STAFF REPORT

PLANNING COMMISSION-CITY OF PACIFICA

FILE NO.: UP-453-83 & PSD-313-83

PROJECT DESCRIPTION: Development of a 182 space recreational vehicle park, related facilities and public access and parking on a vacant 11.9 acre property.

PRELIMINARY
SITE DEVELOPMENT PLAN
 ALIGNMENT, GRADING, DRAINAGE and UTILITIES

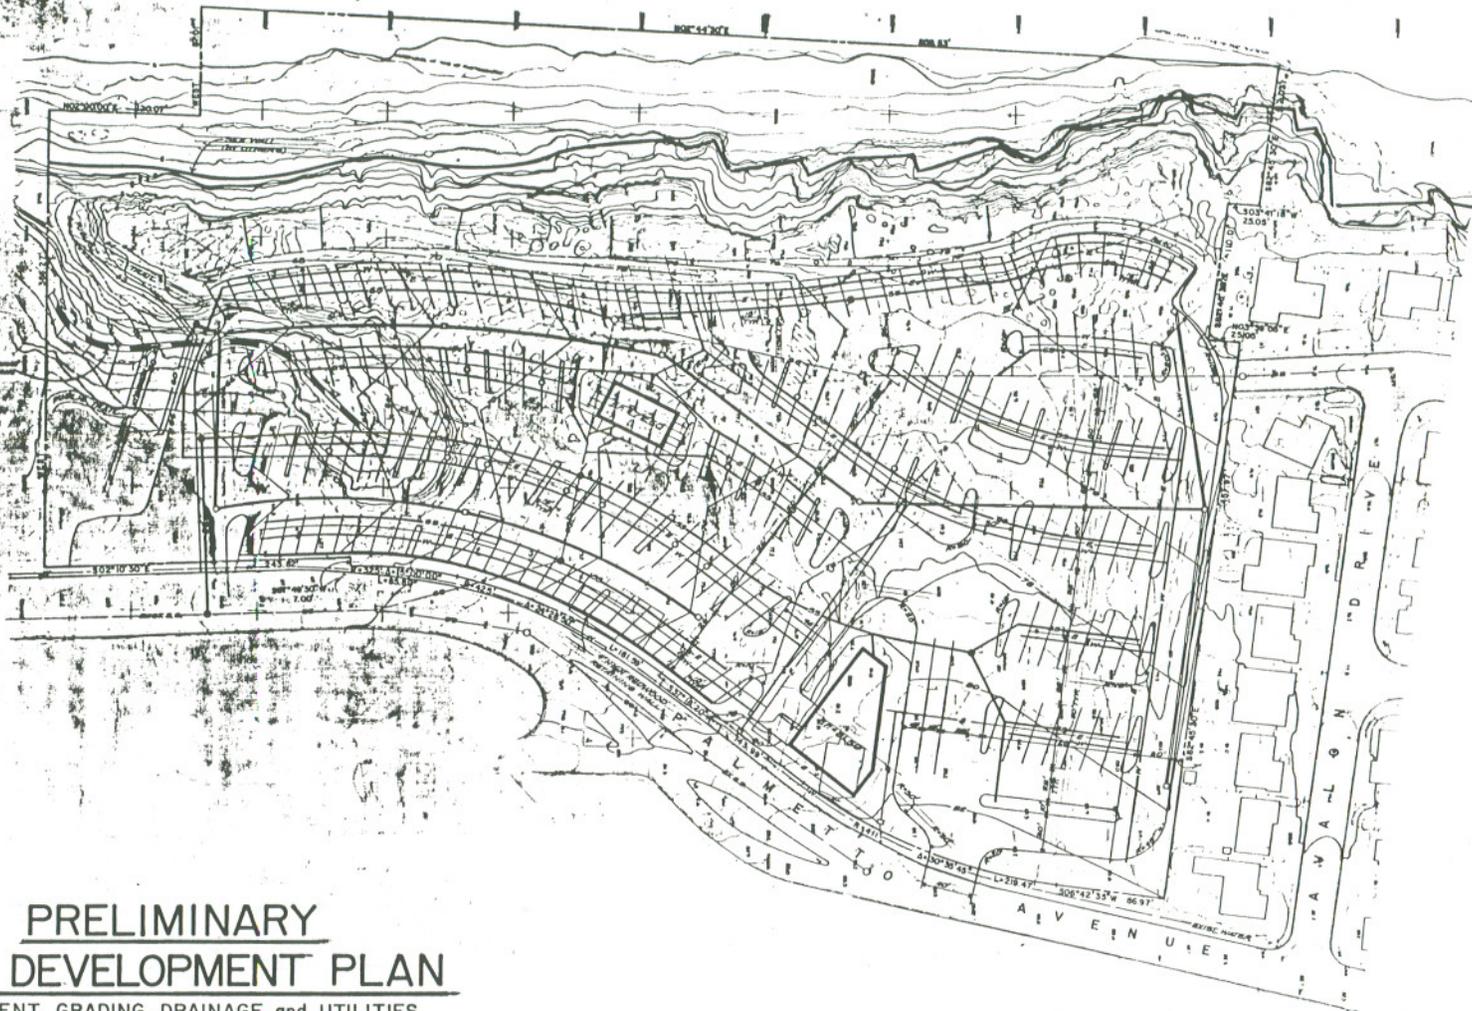
- a. Provision for 20 off-street public parking spaces - 10 spaces are shown.
- b. Protection of views across the site to the ocean from Palmetto Avenue. The preliminary Site Development Plan (Sheet 6) indicates that the site will be graded to be four feet below the street grade of Palmetto Avenue. The only views across the site to the ocean will be those available between vehicles and unoccupied areas.
- c. Establishment of a bluff setback protecting the project from bluff erosion hazards during its economic life. RV spaces are setback 25-45' and the path is setback 1'-25'. Distances are generally greater in the south than the north.

The applicant has not submitted detailed plans showing how vehicular connections to utilities will be accomplished. Staff is satisfied that connections can be made given the current design of spaces. Detailed plans should be submitted prior to issuance of a grading permit for the project. All proposed utility lines are of adequate size to accommodate the project. Special attention should be given to ensuring that all main on-site lines serving spaces are located outside the 75' setback line.

7. Prior to issuance of a grading permit for the project, applicant shall submit a detailed grading, drainage and site improvement plans incorporating recommendations of the Geotechnical Report prepared by Jo Crosby and Associates dated August 5, 1983. Said plans shall locate main sewage collection lines outside the 75' setback recommended for permanent structures.
